## V2500-A1 SERIES PROPULSION SYSTEM SERVICE BULLETIN

This document transmits Revision 1 to Service Bulletin EV2500-72-0463

# V2500-ENG-72-0463

ENGINE – HP COMPRESSOR RING CASES – INCREASE IN TIP CLEARANCE TO STAGE 6 AND STAGE 7  
ROTOR PATHS

HP Compressor Stage 6 Rotor Path  
Figure 1

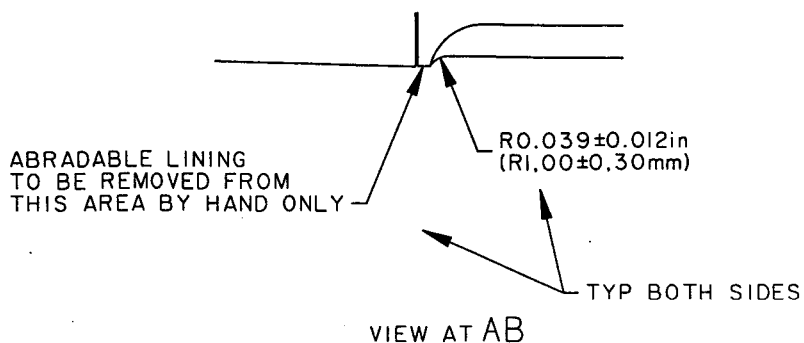
A trench has been introduced to the HP Compressor Stage 6 and Stage 7 Rotor paths across the full axial width of the liners to a nominal depth of 0.018in (0,45mm) and 0.008in (0,20mm), respectively.

NOTE: For SUBTASK 72-41-30-324-052-A000 Para 13.E, refer to Figure 1 and Figure 2 of this Service Bulletin for dimensional profile of Stage 6 Rotor Path.

For SUBTASK 72-41-30-324-052-B000 Para 14.E, refer to Figure 1 and Figure 2 of this Service Bulletin for dimensional profile of Stage 6 Rotor Path.

MACHINE WHERE MARKED ✓.  
MACHINED SURFACE FINISH TO BE 125 MICROINCHES (3.2 MICROMETRES).  
THE GEOMETRIC SYMBOLS ARE AS GIVEN IN THE ISO MANUAL (R1101).

HP Compressor Stage 7 Rotor Path  
Figure 3

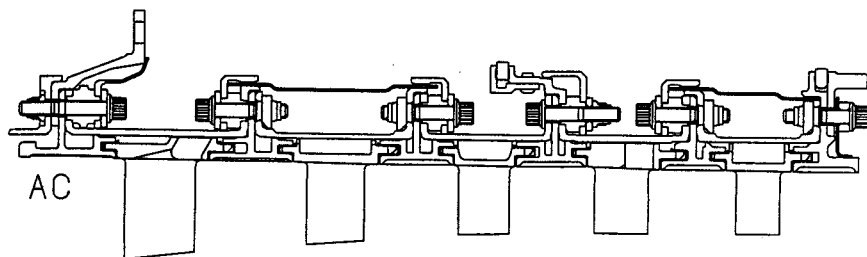
For SUBTASK 72-41-20-324-052 Para 13.F, refer to Figure 3 and Figure 4 of this Service Bulletin for dimensional profile of Stage 7 Rotor Path.

MACHINE WHERE MARKED ✓  
MACHINED SURFACE FINISH TO BE 125 MICROINCHES(3.20 MICROMETRES).  
THE GEOMETRIC SYMBOLS ARE AS GIVEN IN THE ISO MANUAL (RI101).
